## ORIGINATION FORM

Proposed Revisions to a Standard Plans Index  
(Please provide all information — Incomplete forms will be returned)

Index Number: 715-010  
Sheet Number (s): 3  
Index Title: High Mast Light Pole

Change weld on Handhole

HANDHOLE RING

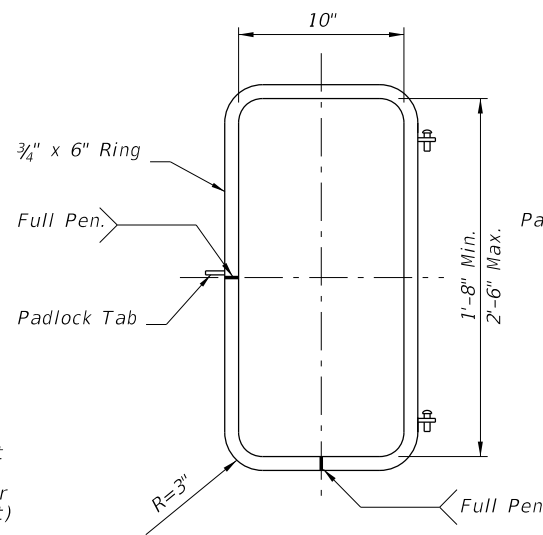
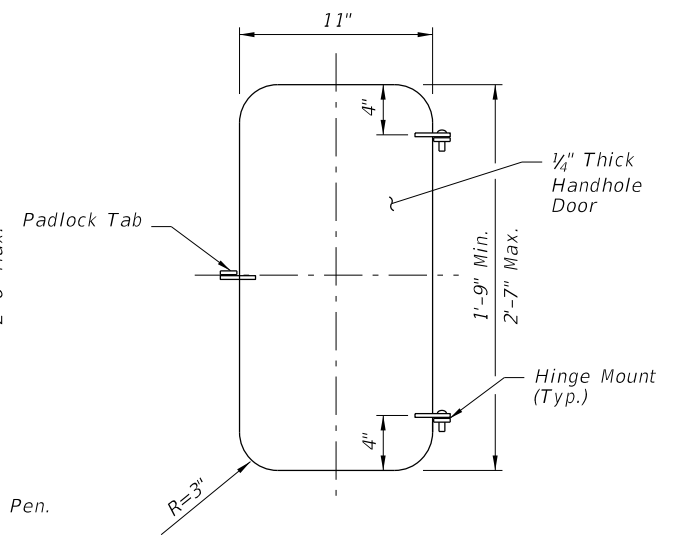
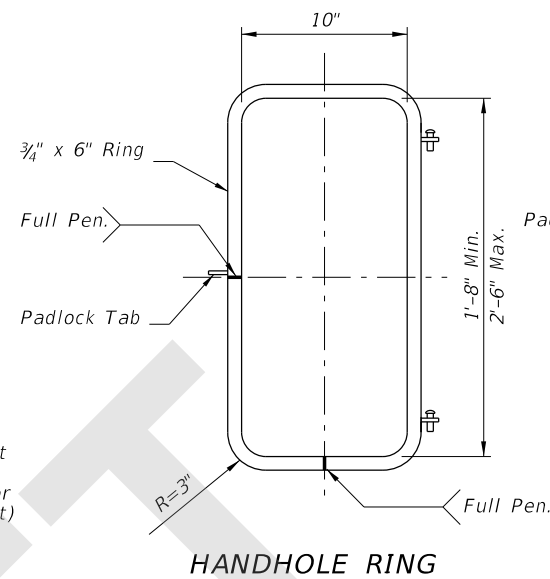
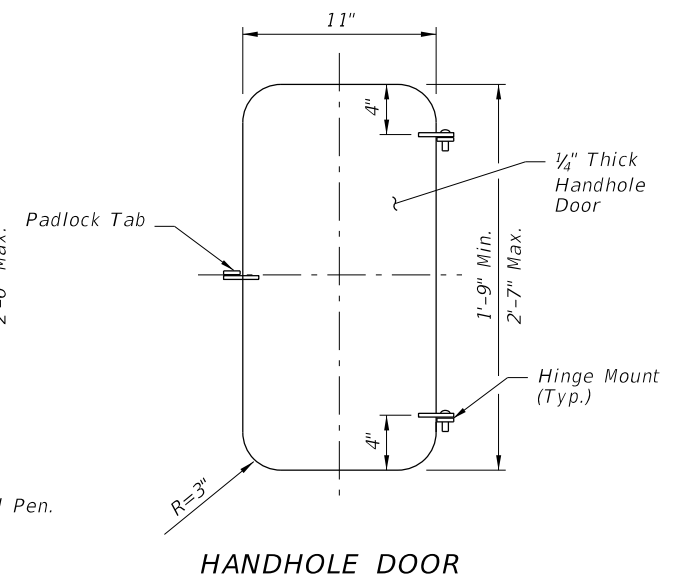
Change weld to meet current criteria as requested by industry.
